# NORTHEAST UTILITIES

Millstone Nuclear Power Station, Unit No. 3  
NRC Radiological Assessment Branch (RAB) Review Meeting

Status of Millstone 3 Draft SER Open Items  
and NRC-RAB Questions Discussed at the Meeting With the NRC-RAB March 1, 1984

Responses to NRC-RAB DSER Open Items  
and Questions Discussed at March 1, 1984 Meeting

FIGURE 3.8-59  
CONTAINMENT STRUCTURE,  
PLAN VIEWS  
MILLSTONE NUCLEAR POWER STATION  
UNIT 3  
FINAL SAFETY ANALYSIS REPORT

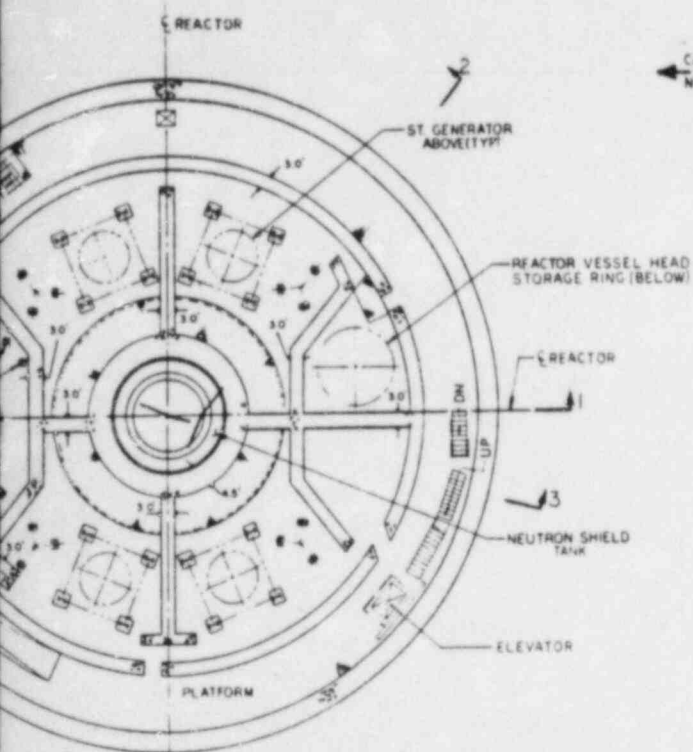
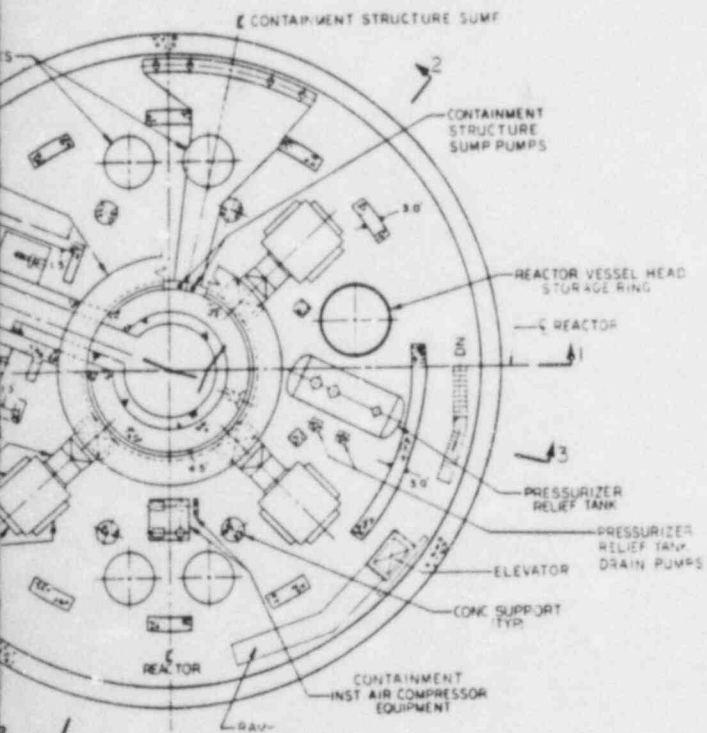
RAB-1 Drawings for High Range Containment Area Monitors (Draft SER Section 12.3.4.1)

Provide drawings which show the locations of area radiation monitors (ARMS).

Refer to revised FSAR Figure 3.8-59.

Response is acceptable.

FIGURE 12.3-12  
UPPER REACTOR CAVITY  
NEUTRON SHIELD  
MILLSTONE NUCLEAR POWER PLANT  
UNIT 3  
FINAL SAFETY ANALYSIS REPORT

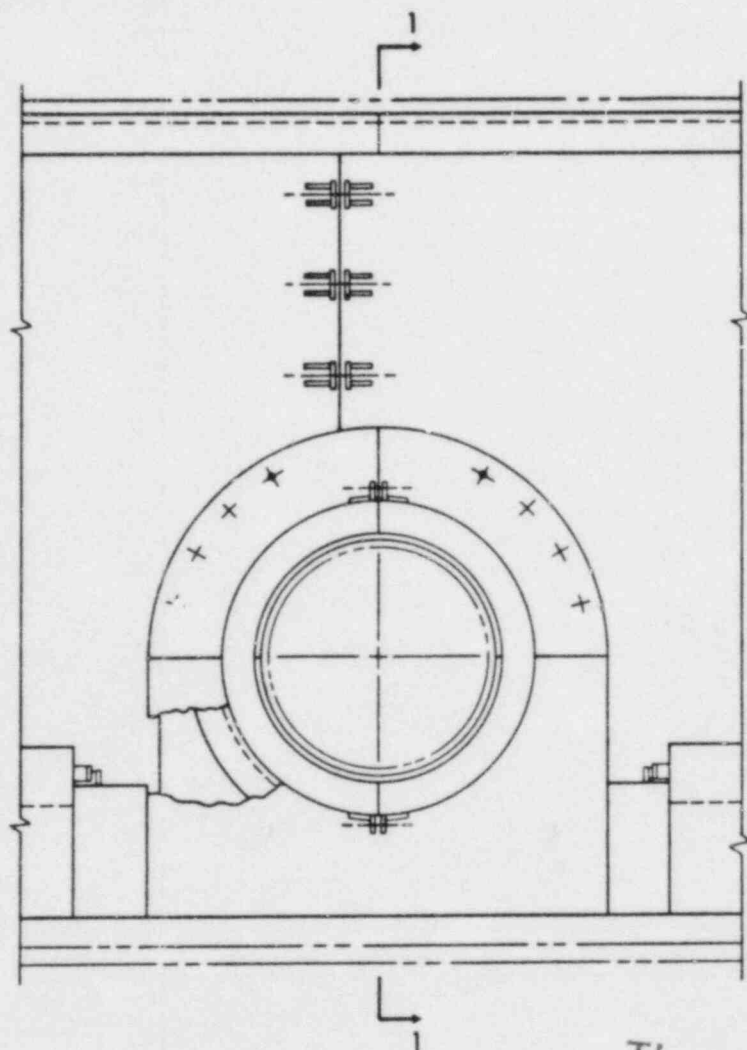
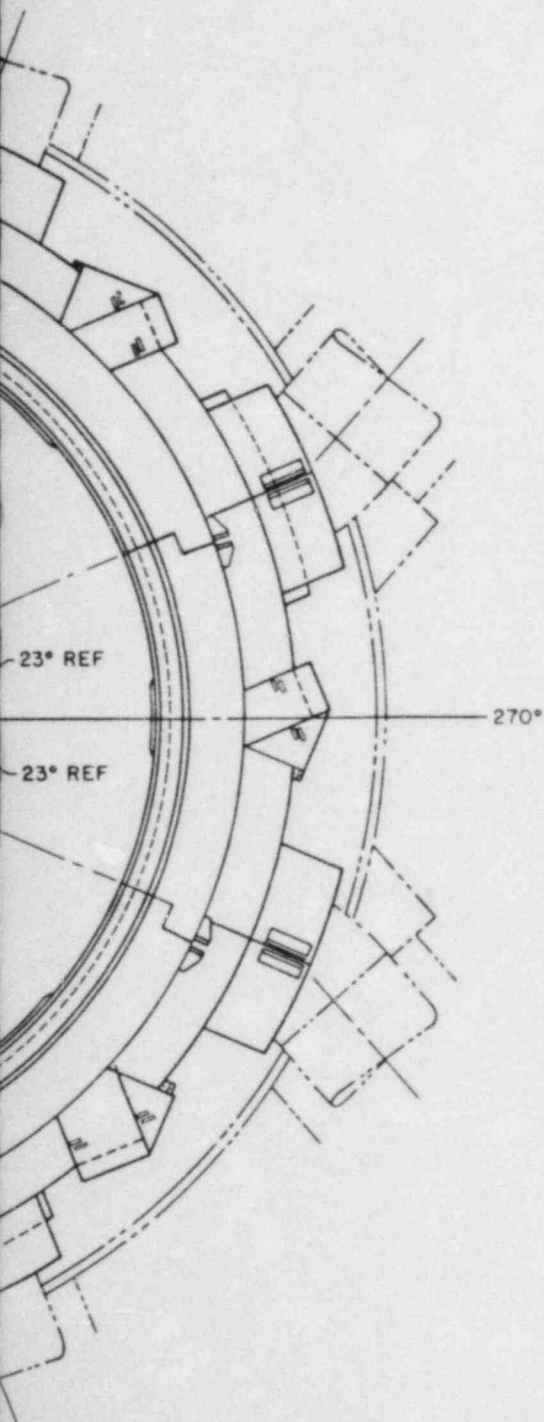
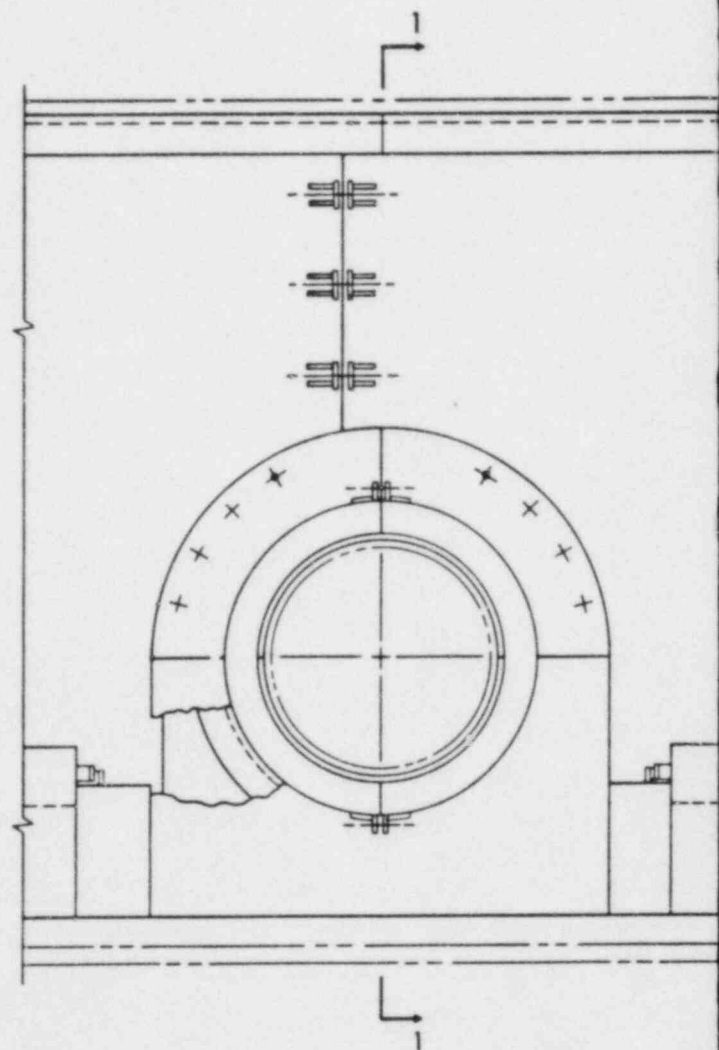
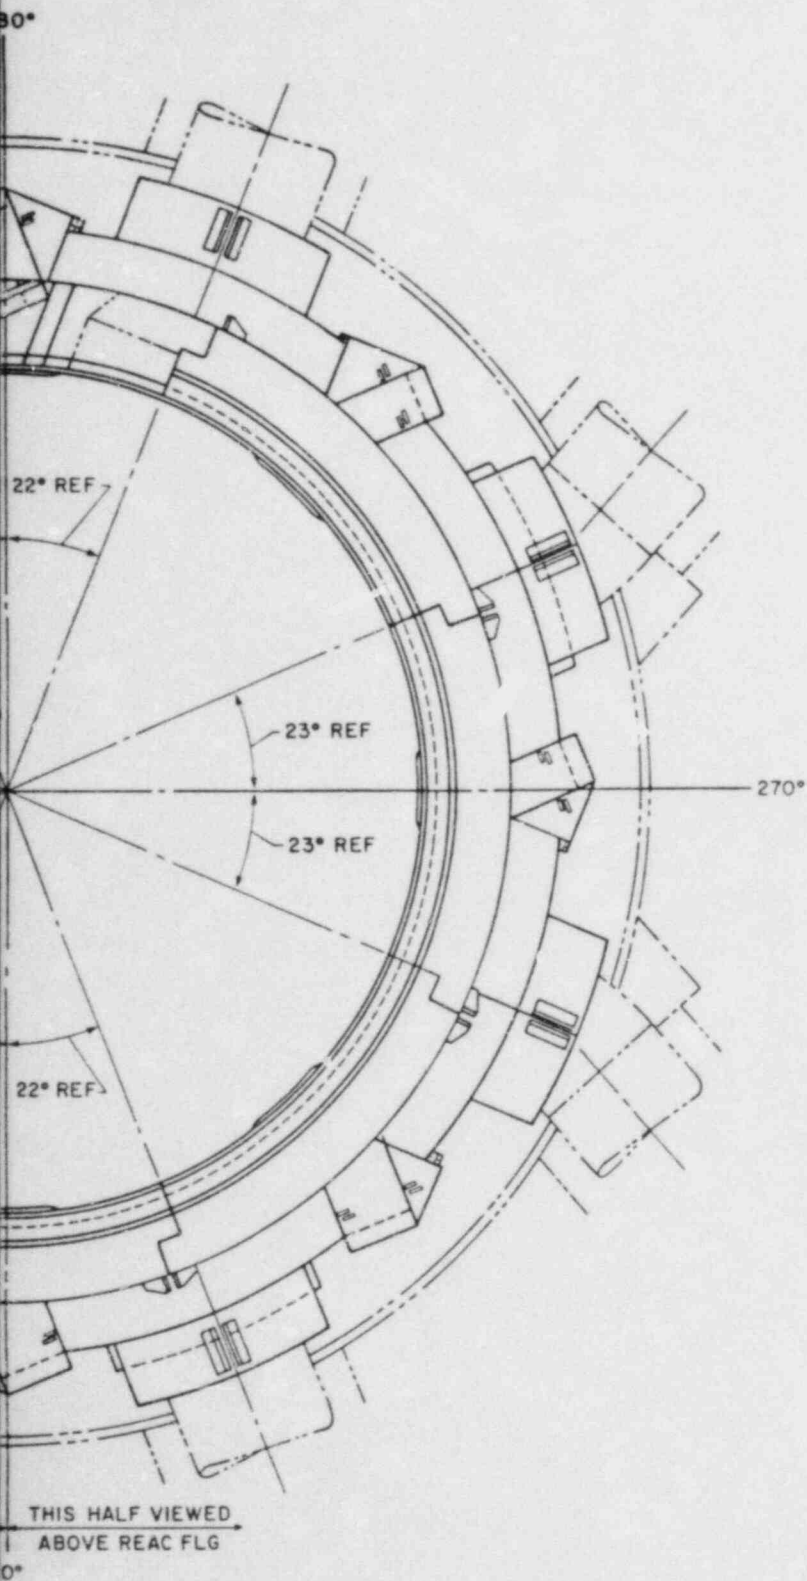
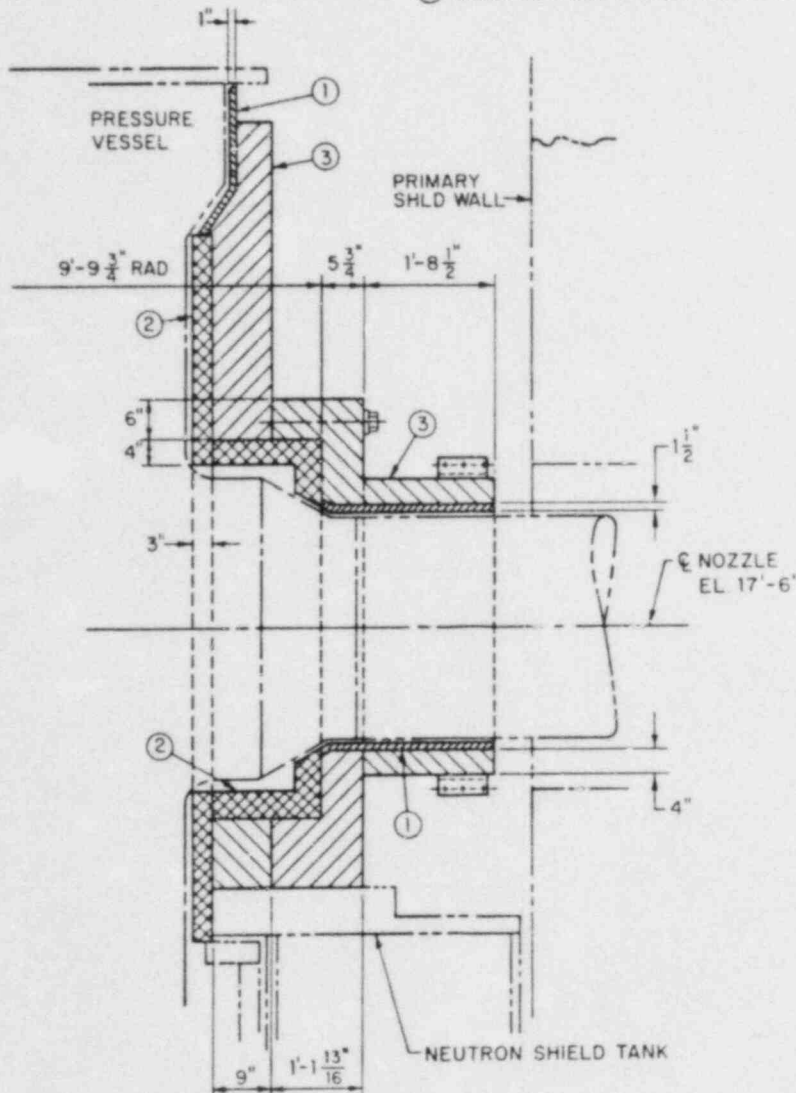
RAB-5 Borated Silicon Shields (Draft SER Section 12.3.2)

Provide a description of the borated silicon shields used in the annular region around the reactor pressure vessel for neutron shielding.

In accordance with the acceptance criteria of Section 12.2 of the 1.12  
SRP, NUREG-0800, your FSAR indicates that borated silicon shields are 1.13  
employed in the annular region for neutron streaming. Provide a 1.14  
description of this shield that includes shield thickness, boron  
loading, and the source strength that your design is based on. 1.15

The primary shield consists of a water filled neutron shield tank and 1.12  
a 4.5-foot thick reinforced concrete shield wall. The neutron shield 1.14  
tank has an annular thickness of 3 feet and is located between the  
reactor vessel and the concrete shield wall. To maintain the 1.16  
integrity of the primary shield, a streaming shield fabricated from  
borated silicon elastomer (Dow Corning Cylgard 170 or equivalent) is 1.17  
installed in the upper annular gap between the vessel flange and the  
neutron shield tank and around the nozzles. (Refer to 1.19 *neutron*  
Figure 12.3-12.)

This shield is designed to minimize the leakage of neutrons to the 1.20  
annular region and streaming to the upper levels of the containment, 1.21  
thus reducing the neutron dose rate on the operating floor, during  
normal operations, to acceptable levels. 1.22 *47.11*
